PROJECT Hillsborough County Sheriff's Office
Firing Range and Workout Gym
Pinebrooke Business Park

PROJECT NUMBER 1626/ 05-07

ADDENUM NO. One (01)
ADDENUM DATE 02/15/17

FOUNDATION PLAN
FIRING RANGE

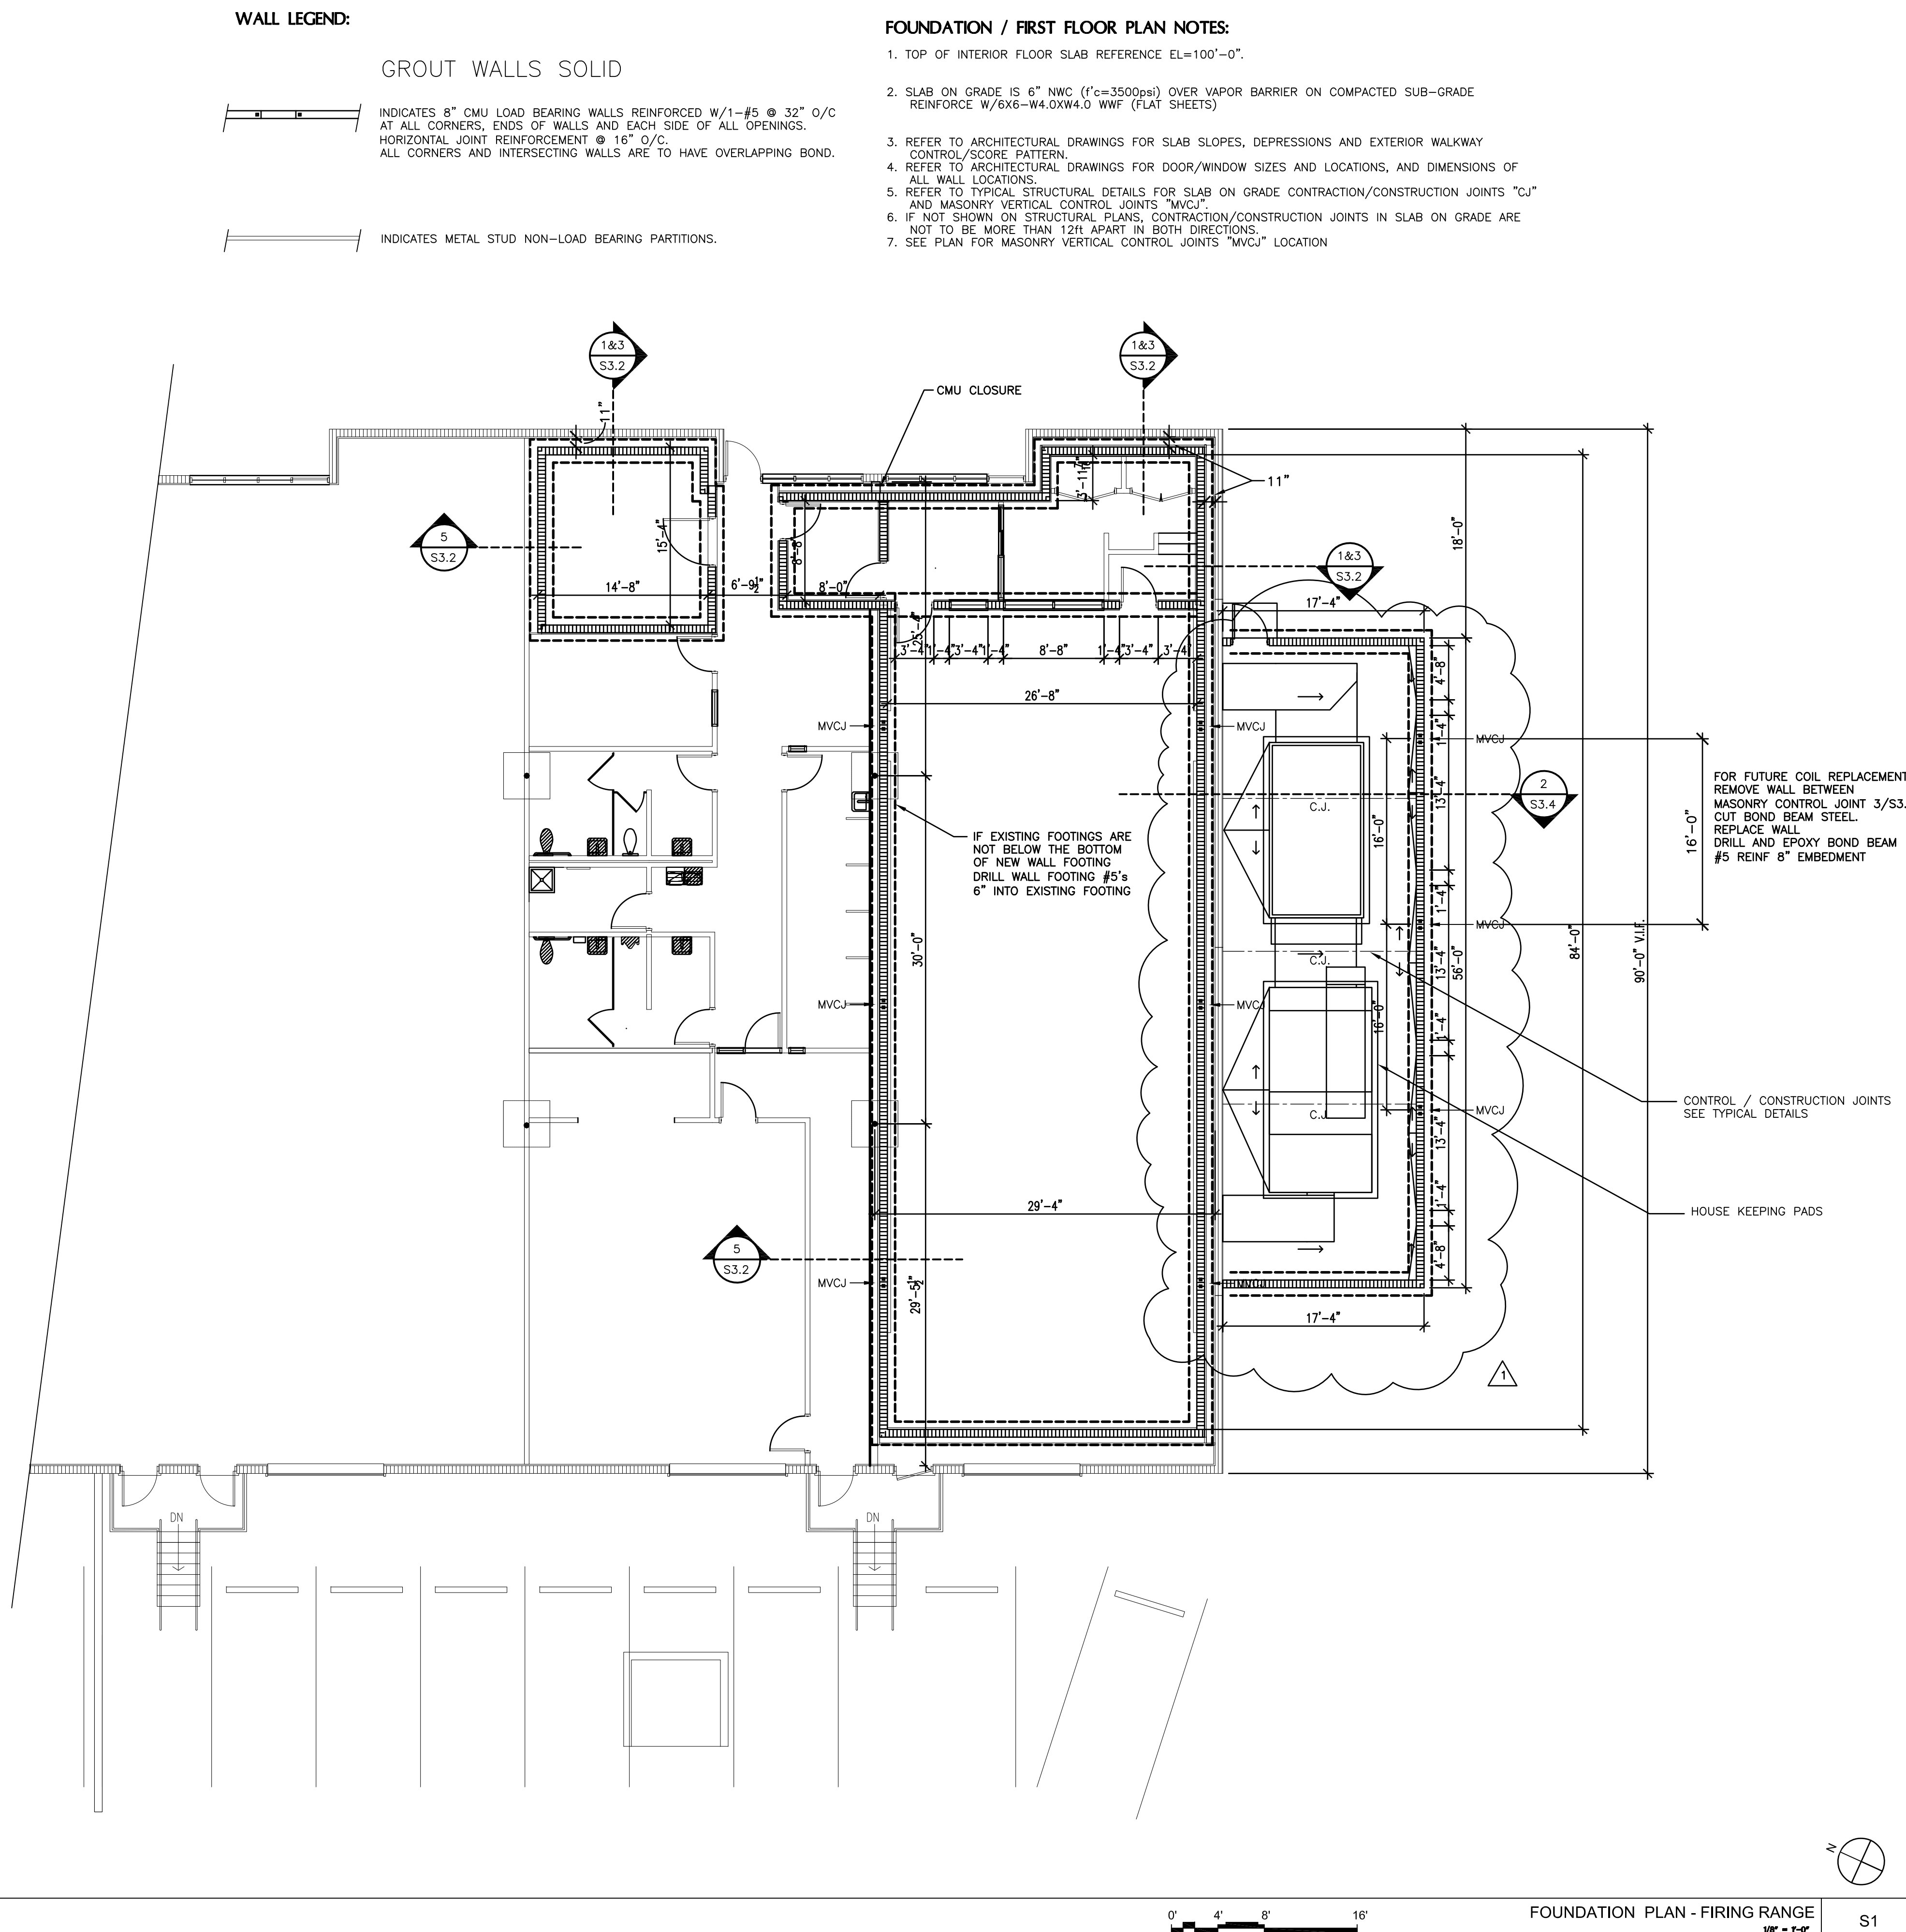
- B. Detail H4 – Revise Detail Number.
 - C. Revise Sheet to include Detail H11.
13. Sheet No. S2.1 – SECTIONS & DETAILS FIRING RANGE
 14. Revise Mechanical enclosure as shown in the revised sheet.

4 SOUTHWEST CORNER OF GYM BUILDING
GAP STABILIZATION DETAIL
3/4" = 1'-0"

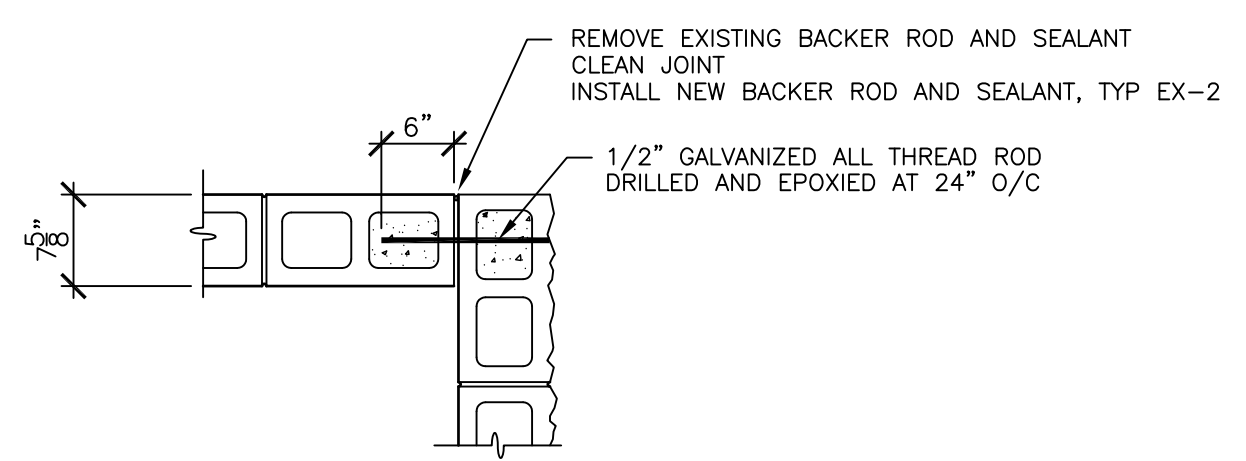
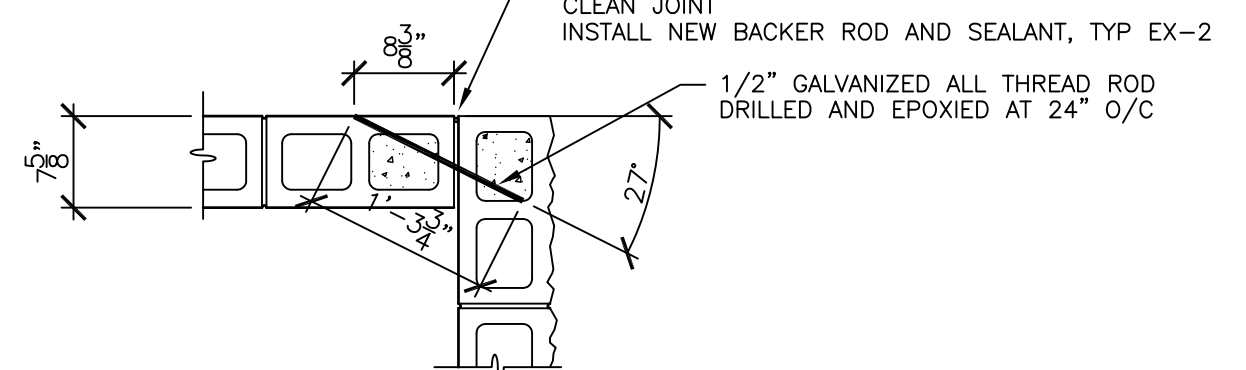
16. Sheet No. S3.4 – SECTIONS & DETAILS FIRING RANGE
 - A. Revise Mechanical enclosure as shown in the revised sheet.
 - B. Revise sheet to include Details 4 & 4A – Southwest Corner of Gym Building – Gap Stabilization Detail.

NOTES:
1. VERIFY CORNER CELLS ARE GROUTED SOLID.
2. IF NOT GROUTED SOLID, CUT HOLE IN UPPER MOST CELL AND GROUT SOLID WITH 3000 PSI GROUT 8-11" SLUMP.
